December 28, 1982

This letter is written in response to your letter of 24 September 1982 regarding our application for approval of our Model 864 package dated 15 July 1982 (Docket No. 71-9166).

SAFETY ANALYSIS REPORT

Revision 1 Insertion Instructions

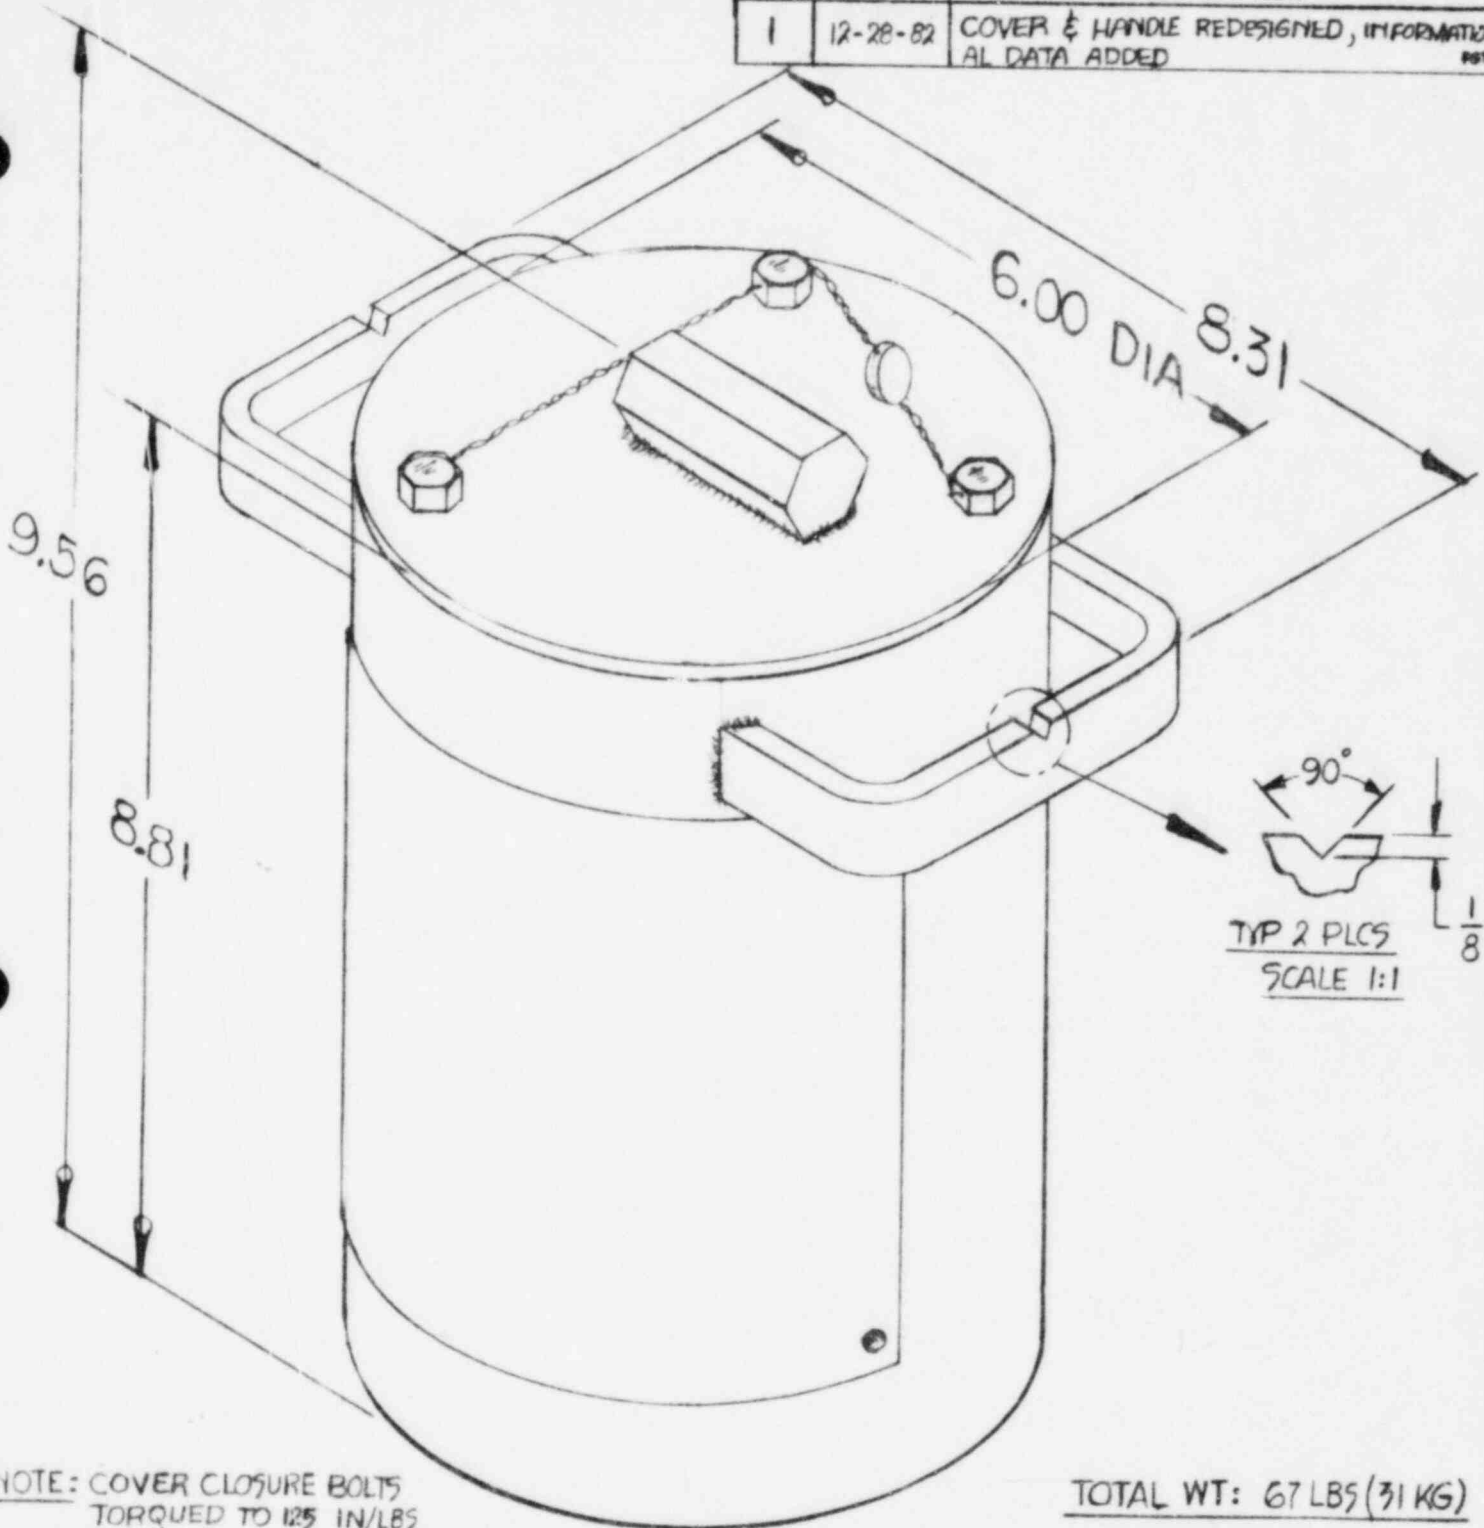
REV.	DATE	DESCRIPTION
1	12-28-82	COVER & HANDLE REDESIGNED, INFORMATIONAL DATA ADDED

MATERIALS AS NOTED		 RADIATION PRODUCTS DIVISION BURLINGTON, MA 01803	
DRAWN BY <i>J. J. ...</i>		PART TITLE GAMMAMAT SOURCE ASSY- DESCRIPTIVE ASSEMBLY	
CHECKED BY APPROVED BY	QUANTITY PARTS XXX FRACTIONS	CLASSIFICATION C	DWG NO. 86491
		SCALE 2:1 & 4:1	REV. 1

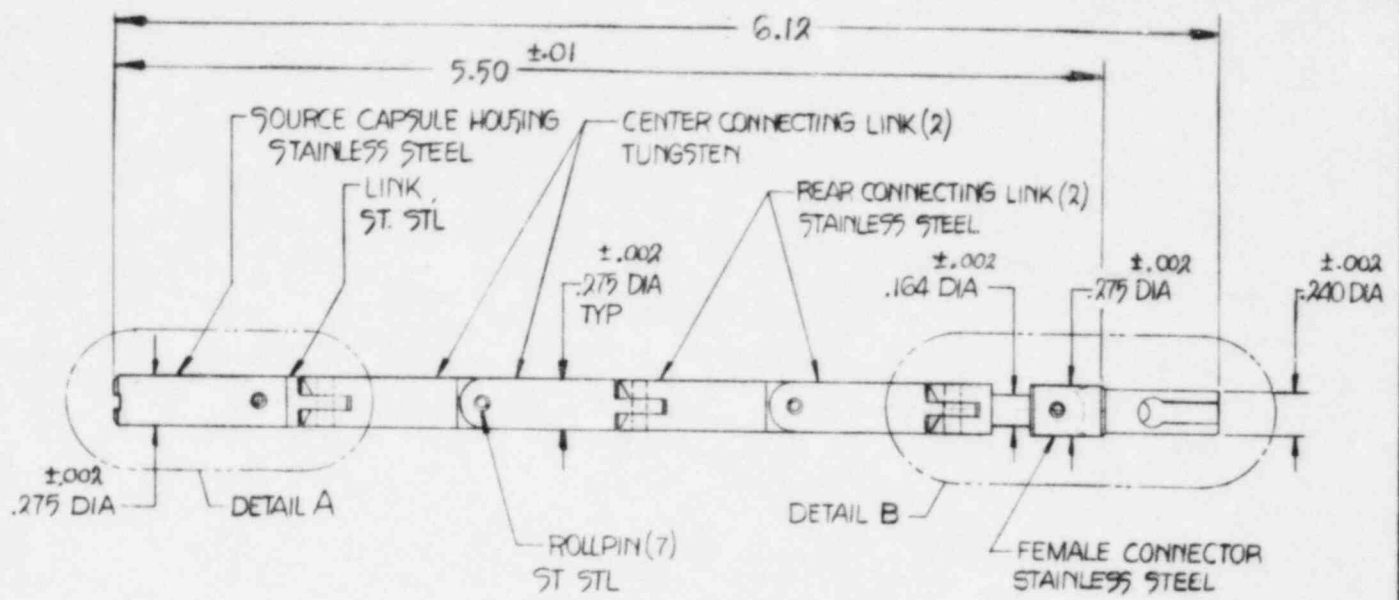
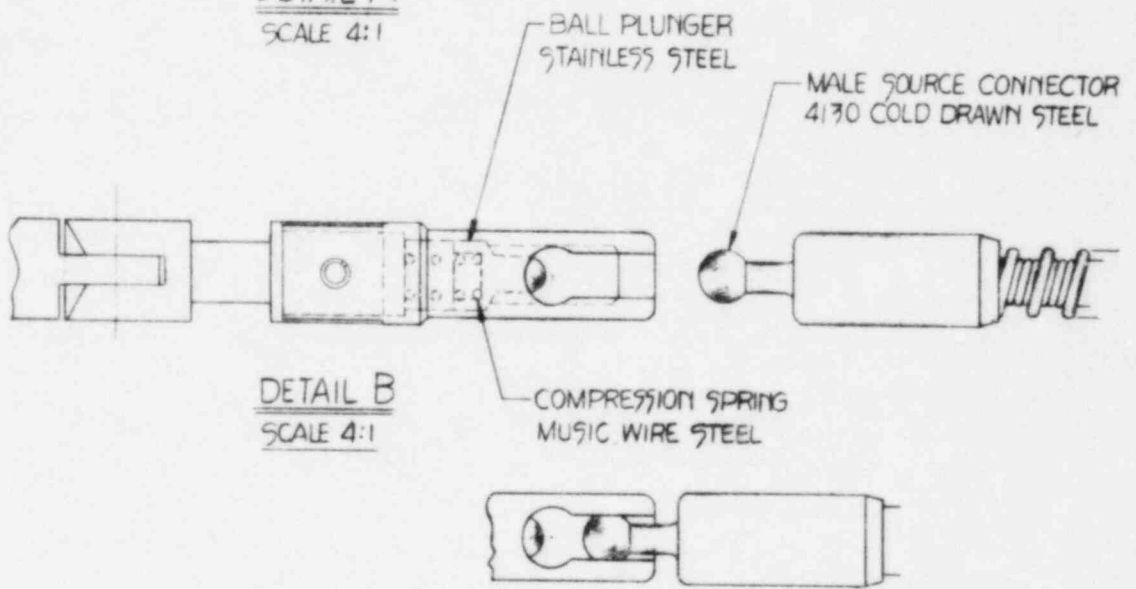
REV.	DATE	DESCRIPTION
1	11-29-52	ADDED TOL. & DIM
